28F400BX/BL
28F004BX/BL
28F200BX/BL
28F002BX/BL

SPECIFICATION UPDATE

Release Date: July 1996

Order Number 297187-008

Erratum Identification/Resolution

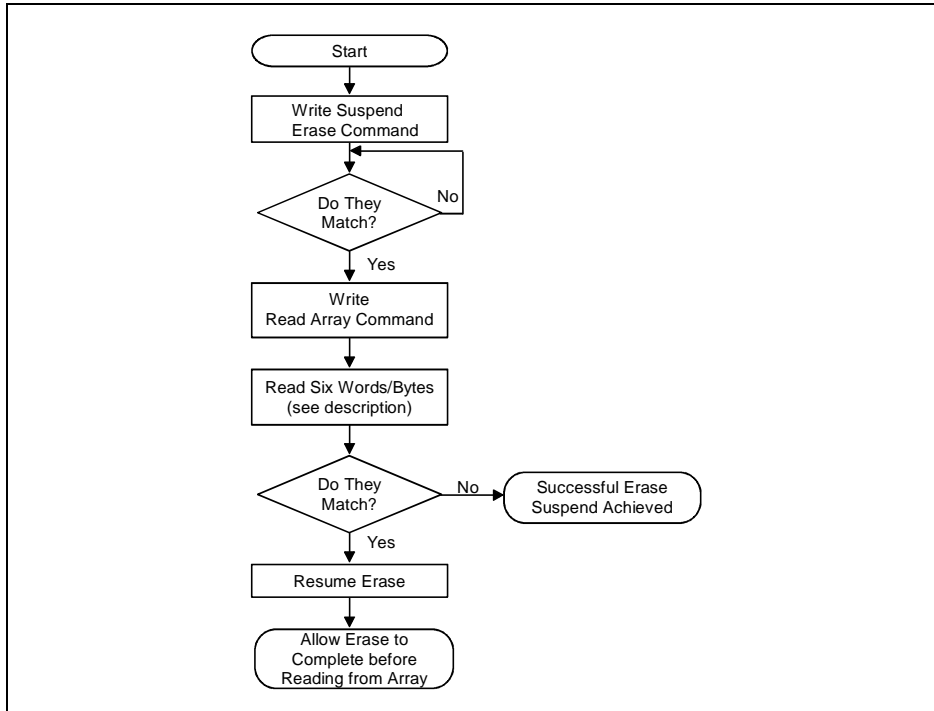
PROBLEM: The 28F400/004/200/002BX/BL enter erase suspend mode when the Erase Suspend command is written to it (while the internal Write State Machine is executing an internal erase algorithm). Polling the Status Register and RY/BY# output will signal to the system that Erase Suspend has occurred. The device is now in erase suspend to status mode and writing the Read Array command will, **in most instances**, signal the device to output array data when read. The device enters a mode referred to as “erase suspend to array.” This allows system software to execute code or read data from blocks of the device.

Affected components in erase suspend to array mode will occasionally, after the Read Array command is written to them, output invalid array data due to an error in the State Machine circuitry. The device in this instance enters an invalid erase suspend mode and outputs invalid data bytes. Statistically, this has occurred approximately once every 500 erase suspend attempts.

WORKAROUND: The following procedure will reliably and consistently alert system software that the devices listed above have entered the invalid erase suspend mode. In almost all cases, this solution will also enable successful erase suspend. Reference the flowchart, *Erratum Identification/Resolution*, which follows, for a graphical description of the steps outlined:

- I. Write the Erase Suspend command to the device.
- II. Poll the Status Register to determine when Erase Suspend has been achieved.
- III. Write the Read Array command to the device.

- IV. Read three words/bytes of data from a block **other than that being erased**.
 - A. At least one of the three words/bytes should have a **known different value** compared to the other two. You must know that at least one of these words/bytes are different from the other two before writing the Erase Suspend command to the device. This can be determined by reading the device in normal read array mode.

- V. If the values at these three locations **do not** match (as expected, because one of the words/bytes was determined to be different from the other two, before writing the Erase Suspend command), erase suspend to array mode has been entered successfully.

- VI. If the values at these three locations match, erase suspend to array mode has not been entered successfully on this attempt. Instead, the invalid erase suspend mode has been entered. Write the Erase Resume command to the device.
- VII. Read the device outputs (poll the Status Register) to determine when erase resumption has been achieved.
- VIII. Wait 50 μ s.
- IX. Re-execute the erase suspend attempt up to two more times (or three times total).
- X. If not successful after three attempts, issue the Erase Resume command, and allow the internal erase algorithm to complete before attempting to read from the array.

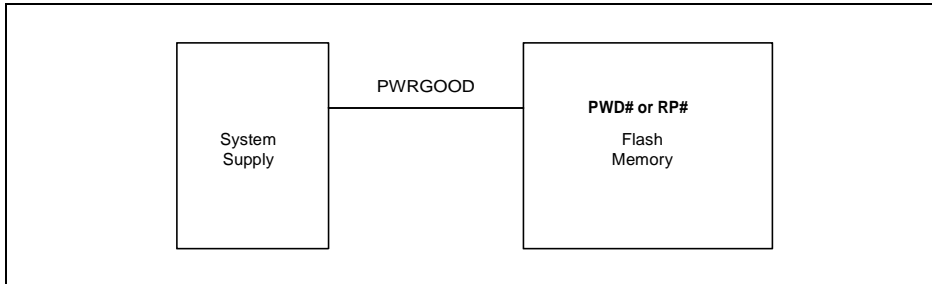
PROBLEM: The devices listed above do not meet the V_{LKO} , V_{CC} Erase/Write Lock Voltage, minimum specification of 2.0 volts when operating in **3.3V** mode. Instead, the described devices meet a minimum V_{LKO} voltage of **1.7 volts**.

The lowered V_{LKO} specification reduces spurious-write protection using V_{LKO} at 3.3V. However, V_{LKO} is only one of several methods available for preventing unwanted command writes.

Intel Flash memories offer multiple protection mechanisms against spurious command writes, especially during power transitions. Upon power-up, the described devices are indifferent as to which supply, V_{PP} or V_{CC} , ramps first. Power supply sequencing is not required. The V_{LKO} protection mechanism inhibits command writes to the flash for V_{CC} below V_{LKO} . Additional protection methods should be used, as described below, to prevent spurious command writes for V_{CC} voltages above V_{LKO} .

Pin Identification

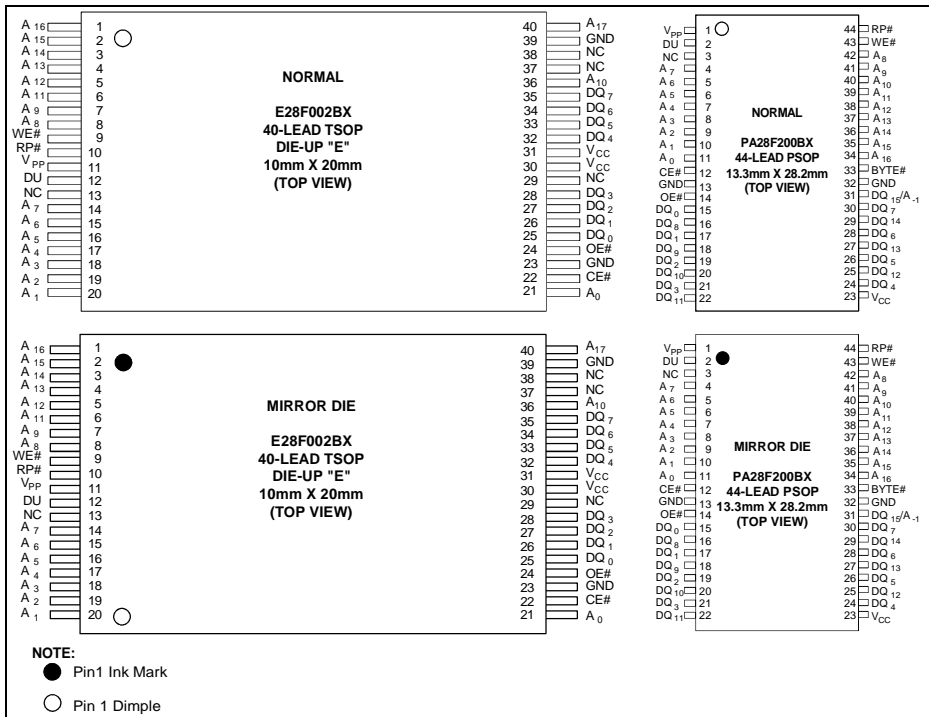
PROBLEM: The die from the first few lots of the 28F200/002BX 2-Mbit Boot Block flash memory were mirror-imaged. These mirrored die have been qualified and found to be identical in every way to subsequent normal devices. However, some package markings had to be altered to identify this difference.

The 28F200/002BX is offered in the die-up TSOP and PSOP packages. Affected materials include both the 40-lead TSOP and the 44-lead PSOP packages. After some testing and package assessment, the mirrored die was inversely placed (i.e., built as die-down) in the die-up packages. A white dot is painted on the top, near the left-hand corner to indicate the position of pin 1. The distinguishing characteristics of these different package types are explained in the *Pin Identification* figure below.

Affected materials will be distinguished by an ink **mark** indicator for pin 1 in the upper left-hand corner of the device. All material not affected by this erratum will have the normal pin 1 dimple in the upper left hand corner. If the ink mark is present, the dimple should be ignored. There are some devices on which the ink mark indicating pin 1 is absent. If a device is suspected to be a mirrored-die product, please contact the local Intel representative for a replacement.
